Subject: Approval of Plans and Specifications for the Reconstruction of Taxiway F (renamed A) at Oxnard Airport, Including Addenda Nos. 1-2; Waiver of Any Minor Irregularities in the Bid; Award a Contract for the Base Bid Schedule I to Security Paving Company, Inc., in the Amount of \$17,365,009.50, on the Basis of the Lowest Responsive Bid, Conditioned Upon Receipt of a Federal Aviation Administration and/or CalTrans Grants and/or Airport Enterprise Funds Sufficient to Fund Project Costs; Authorization for the Director of Airports, or Designee, to Execute the Subject Contract, if Awarded. (Exhibit 1 is available for review on the Department of Airports website www.vcairports.org)

To: Plan Holders for Improvements to the
Oxnard Airport
Oxnard, California
AIP Project No. 3-06-0179-043-2023
County of Ventura DOA Spec. No. OXR 23-03, Project No. OXR-150

**ADDENDUM NO. 1 TO
CONTRACT DOCUMENTS, SPECIFICATIONS AND PLANS
FOR IMPROVEMENTS TO THE
OXNARD AIRPORT
OXNARD, CALIFORNIA
AIP PROJECT NO. 3-06-0179-043-2023
COUNTY OF VENTURA DOA SPEC. NO. OXR 23-03, PROJECT NO. OXR-150**

**ADDENDUM NO. 2 TO
CONTRACT DOCUMENTS, SPECIFICATIONS AND PLANS
FOR IMPROVEMENTS TO THE
OXNARD AIRPORT
OXNARD,

ELECTRICAL DETAILS		SHEET NAME	
AIP PROJECT NO.	JVIATION PROJ. NO.	SHEET NO.	E253
3-06-0179-043-2023	2023 OXR-01	89 of 89	
SPEC. NO.	COUNTY PROJ. NO.	DRAWING NO.	1674-DOA
DOA 23-03	OXR-150

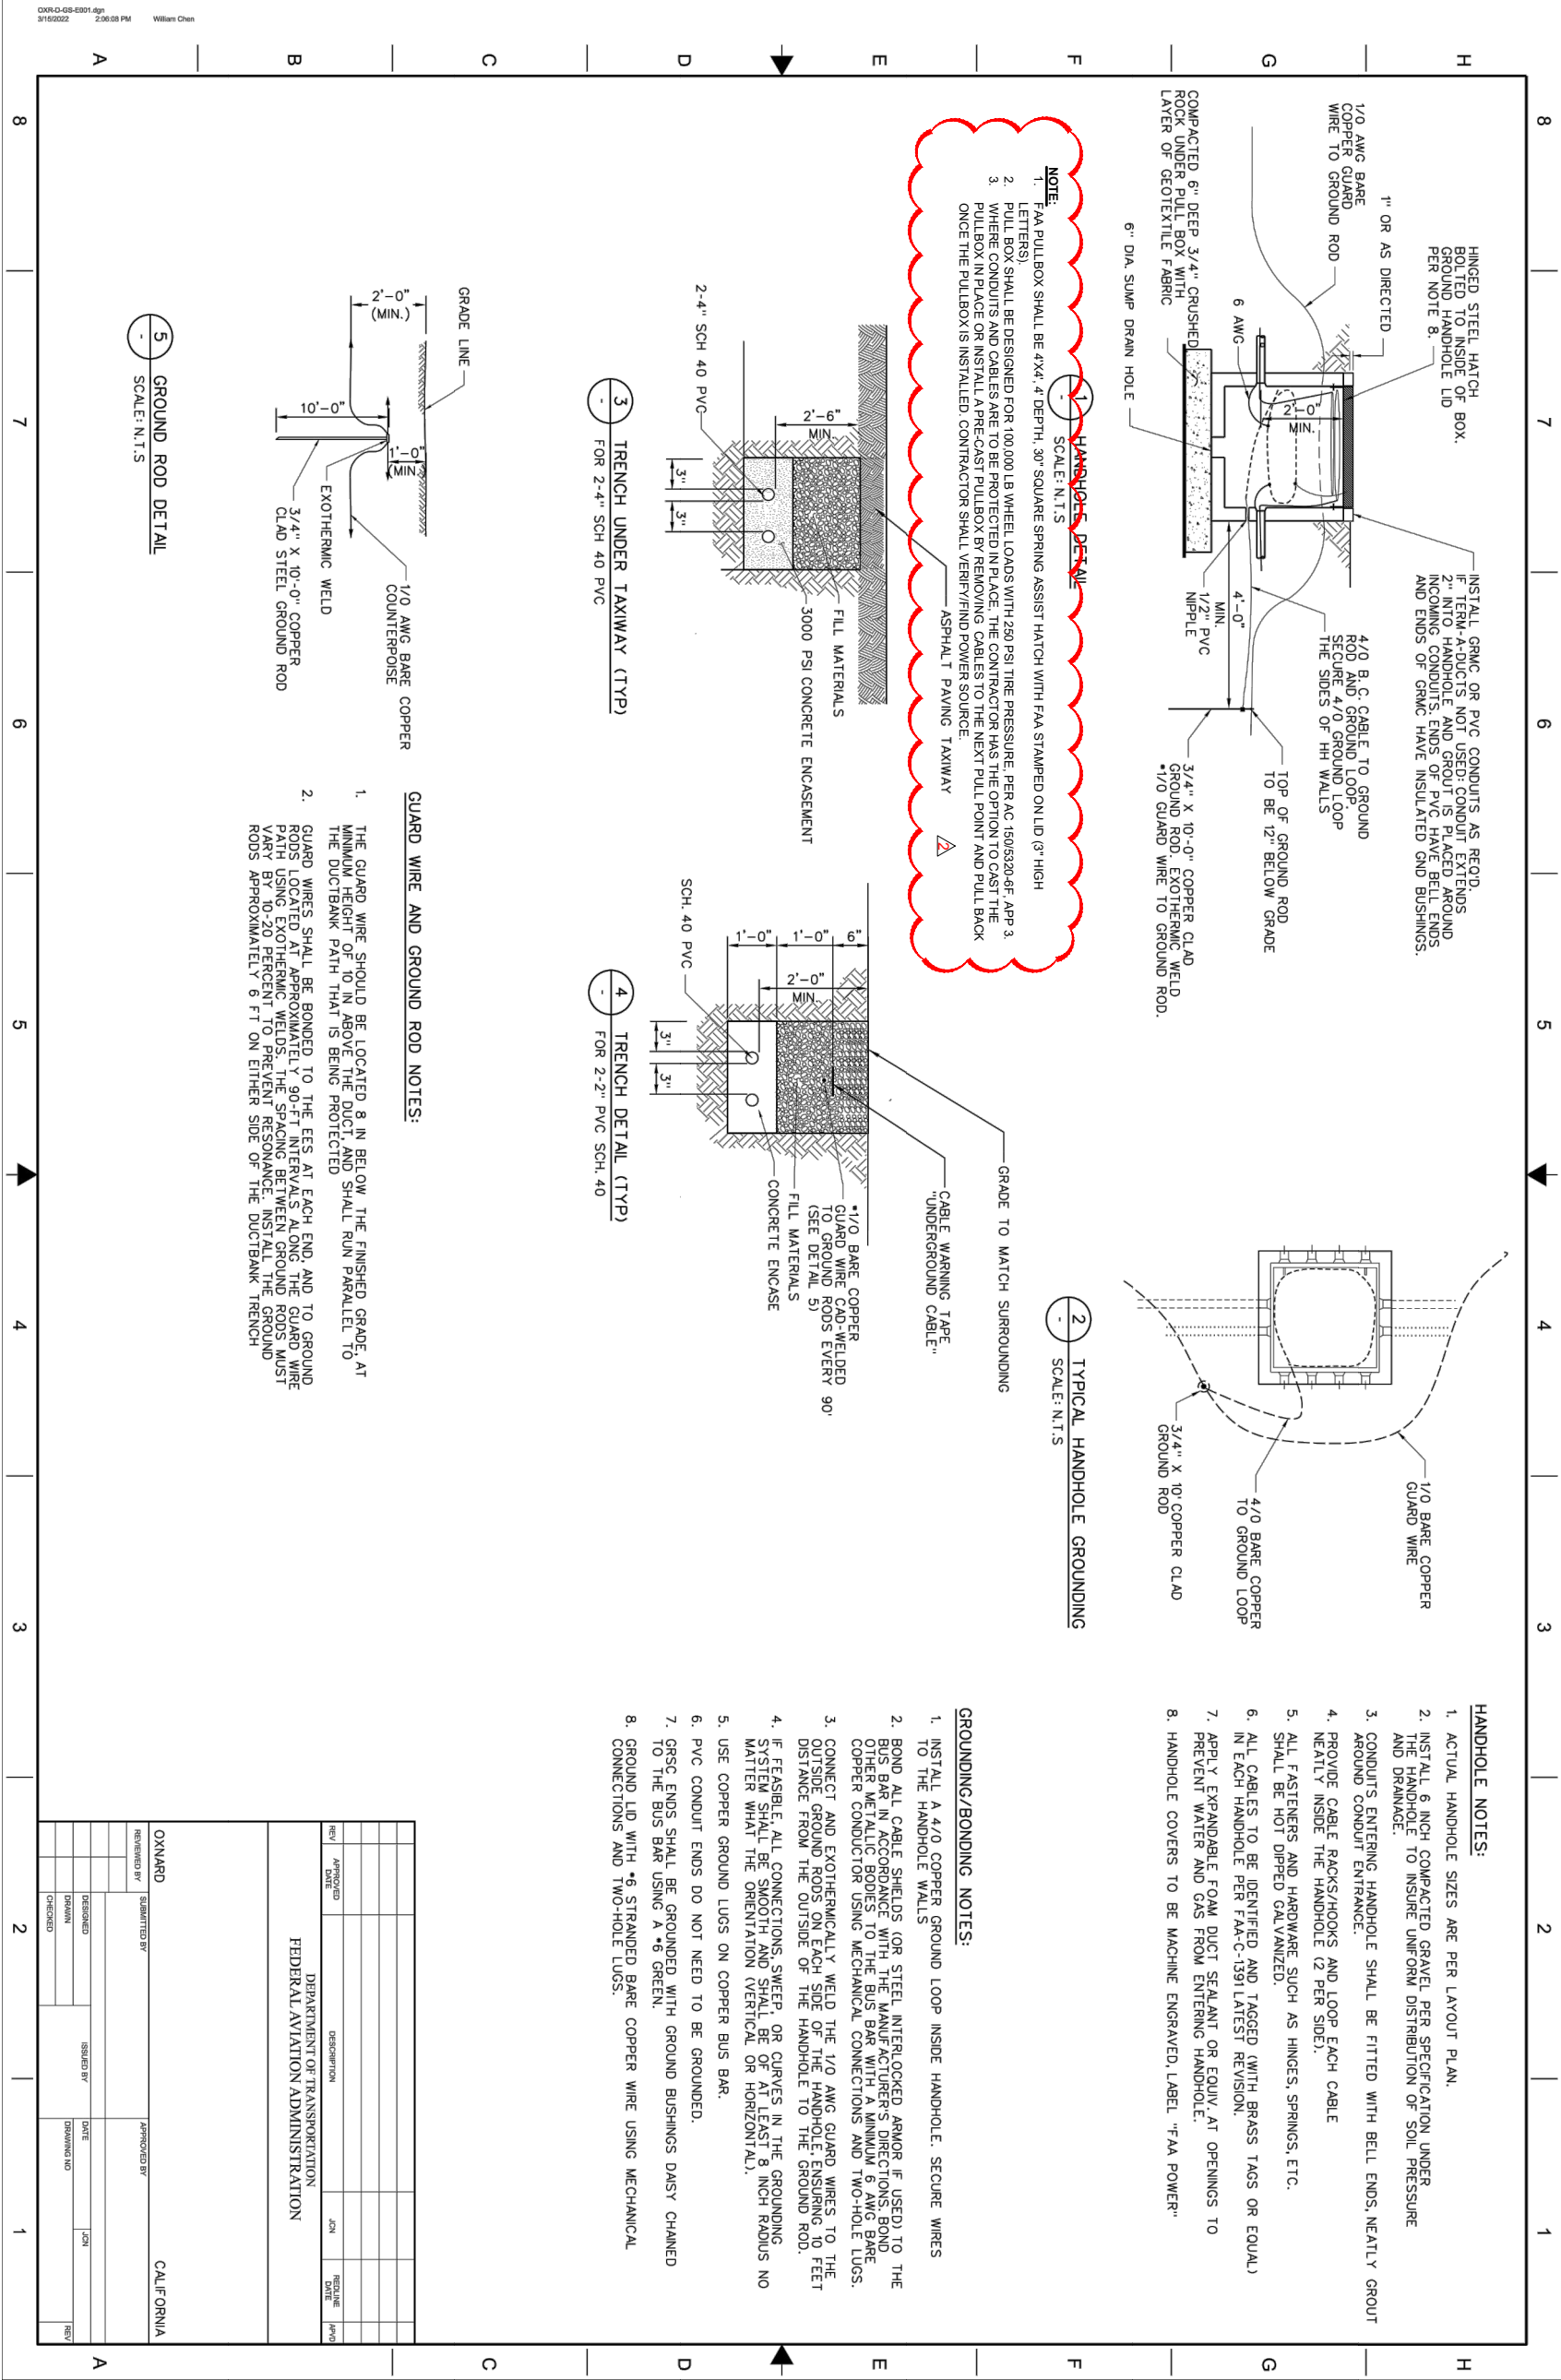
Sheet E253, ELECTRICAL DETAILS. Notes were added to Detail 1, Handhole Detail.

Justification: The FAA handholes shall be aircraft rated, and dimensions were added.
